JEFFERSON COUNTY
PLEASURE ISLAND SHORE PROTECTION
REVISED BREAKWATER-MARSH RESTORATION PROJECT

Addendum No. 1**Project Extension—Additive Alternates 1 and 2**

February 6, 2012 (updated February 19, 2013 to include contract time extensions)

Exhibit A

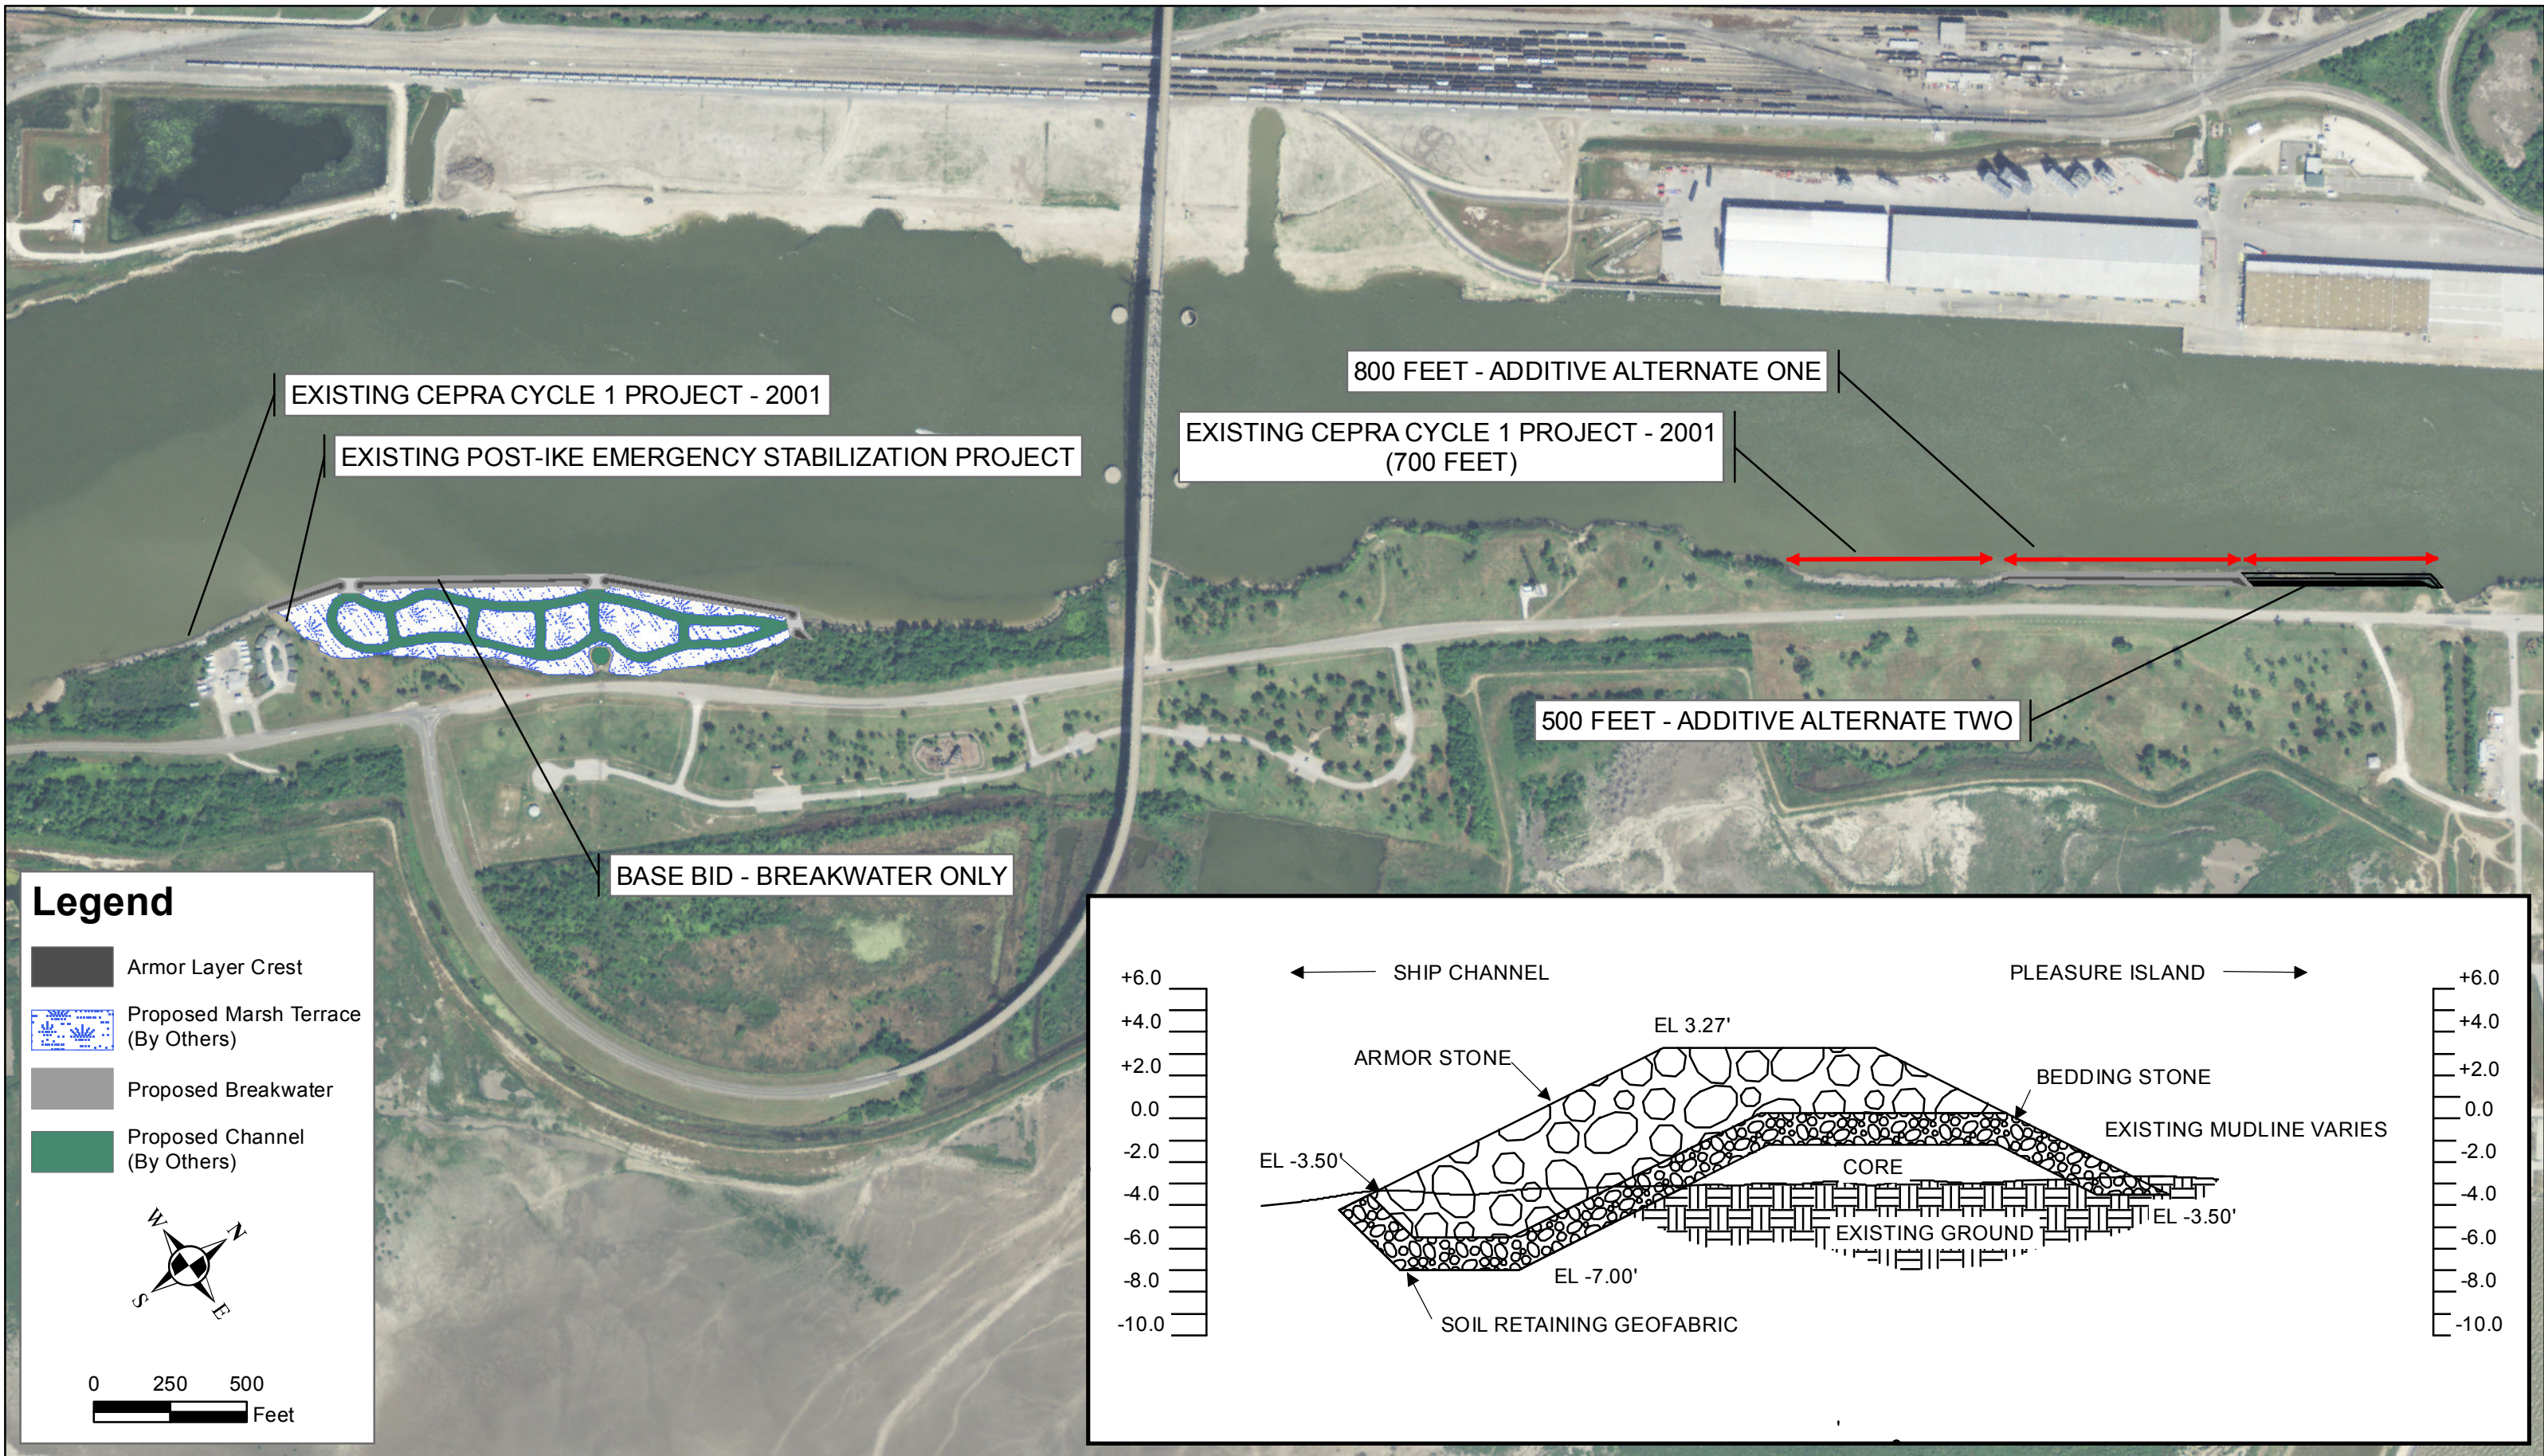
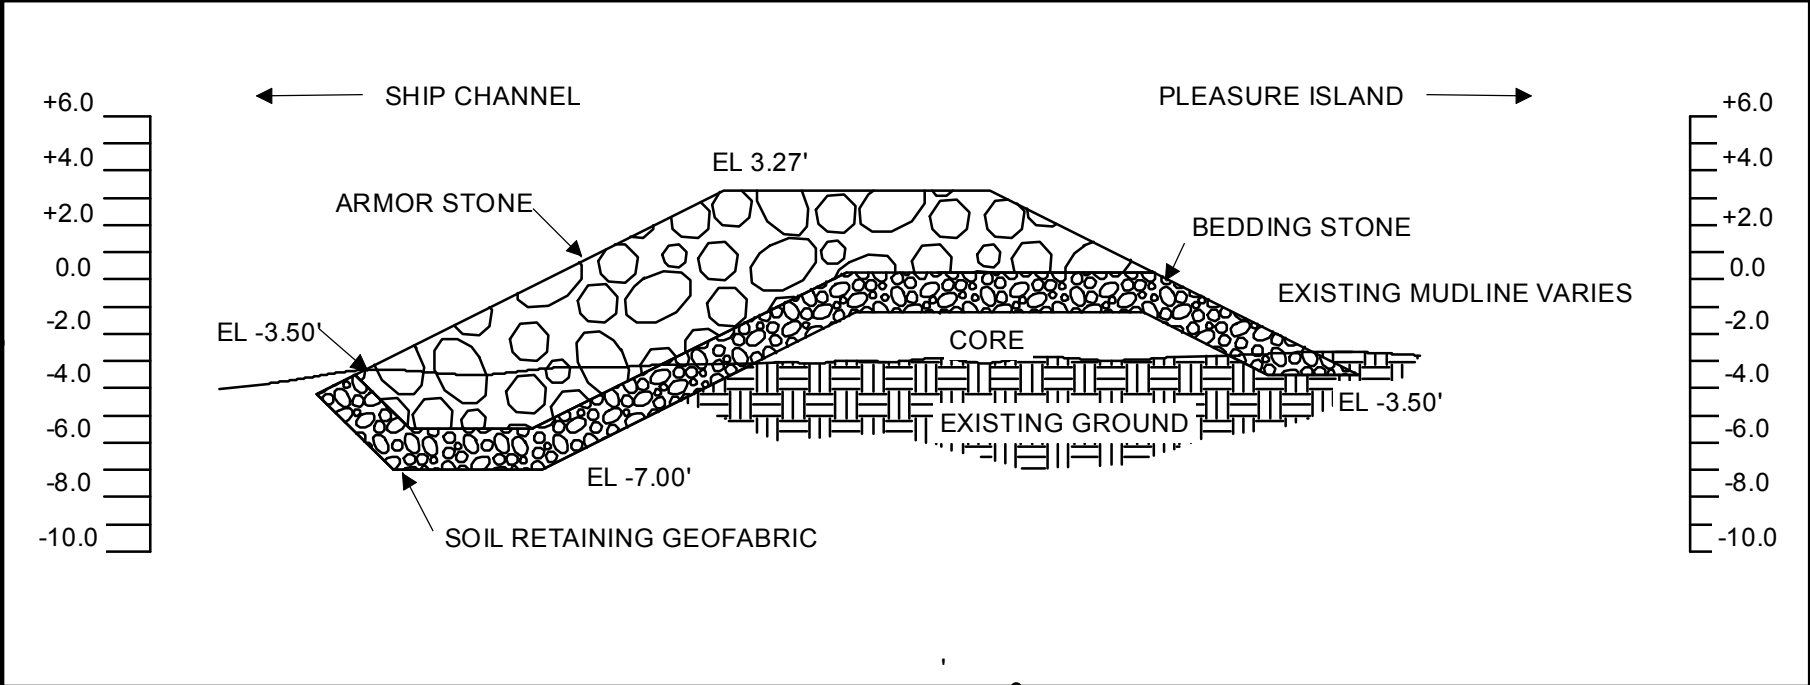
Owner desires to execute one or both of the additive alternates described below if funding becomes available prior to contract award. The intent of the additional work is to address an erosion hotspot located roughly one mile north of the base bid work along the Pleasure Island shoreline. This location is roughly 3,000 feet north of the MLK Bridge and directly across the channel from the Port of Port Arthur. The hotspot threatens the integrity of T.B. Ellison Parkway. As shown in Exhibit A, the south end of the additive work will connect to a previously constructed rock revetment in a similar manner as the base bid work, and the base bid typical section will be used. All provisions of the Contract Documents applicable to the base bid work will apply to the additive work.

Item 1:**ADDITIVE ALTERNATE BID 1 – 800 FT OF TYPE 1 BREAKWATER**

The Work consists of 800 ft breakwater using the Type 1 breakwater typical section found on Sheet 079A-1009-C-1005 of the Drawings.

Item 2:**ADDITIVE ALTERNATE BID 2 – 500 FT OF TYPE 1 BREAKWATER**

The Work consists of 500 ft breakwater using the Type 1 breakwater typical section found on Sheet 079A-1009-C-1005 of the Drawings.

Add Alt 2 extends the length of breakwater included in Add Alt 1 with no transition section required between the two. An end transition of a maximum length of 10 ft shall blend with concrete riprap at the north end of new construction, adjacent to the drainage outfall at that location. Pay quantities relating to the end transition may be adjusted to account for any significant variation relative to unit quantities represented in the typical section. The contract time will be extended by thirty (30) days for the work of Item 2, in addition to the extension for Item 1.
